ADDENDUM NUMBER TWO

**TITLE: INVASION BIOLOGY & RESTORATION ECOLOGY
FACILITY, URI**

DOCUMENT 00900 - ADDENDA AND MODIFICATIONS

ADDENDUM NO. 2 – September 7, 2012

A-SK-1

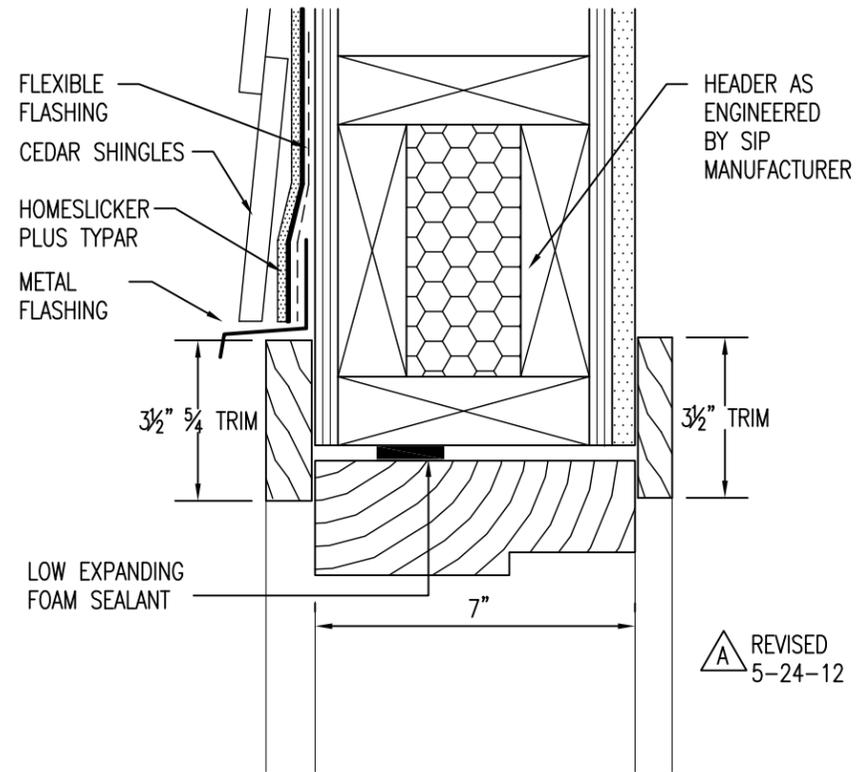
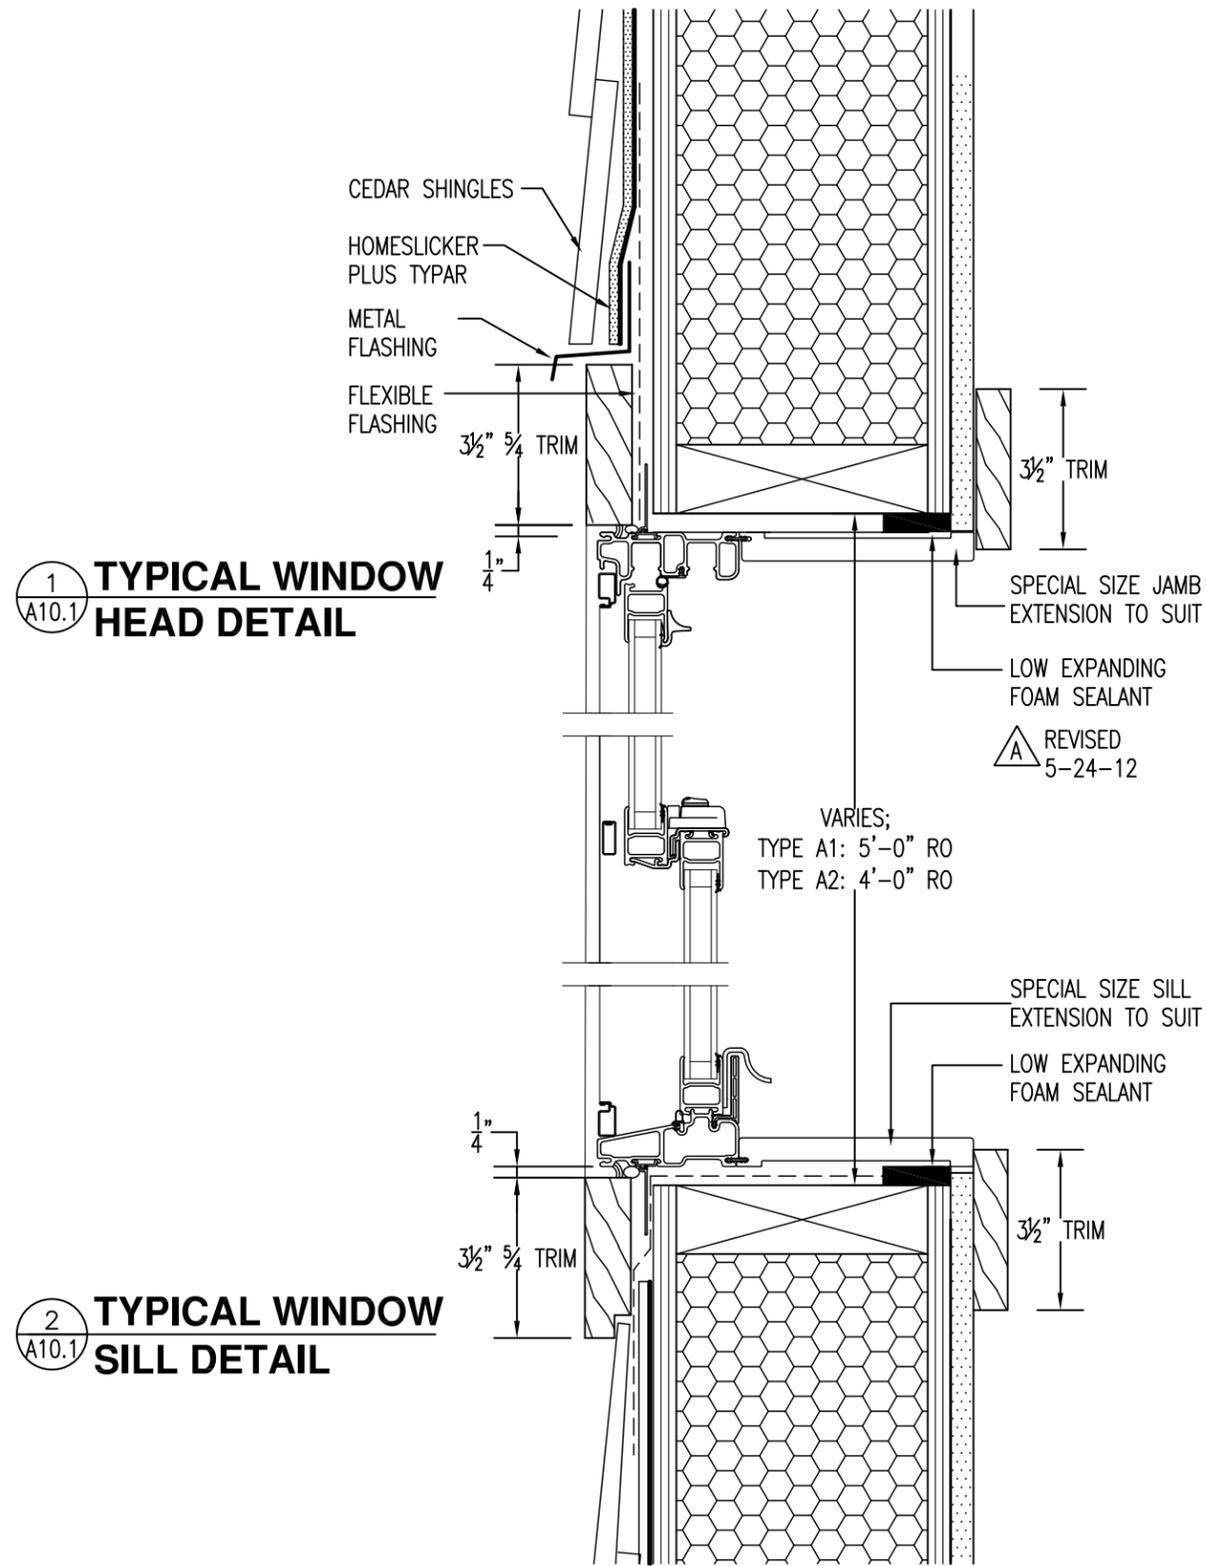
18. At Doors Nos. 1 and 2, change Door Type to “Flush Fiberglass”.
19. At Door #3, change Door Type to “Flush Wood” and delete listing of “Aluminum Threshold.”
20. At Door Types, change Type 1 Elevation to show Flush Face Door.
21. Delete Details 1/A10.1, 2/A10.1 and 3/A10.1 and insert revised Details 1/A10.1, 2/A10.1 and 3/A10.1, as illustrated in A-SK-1 issued as part of this addendum.
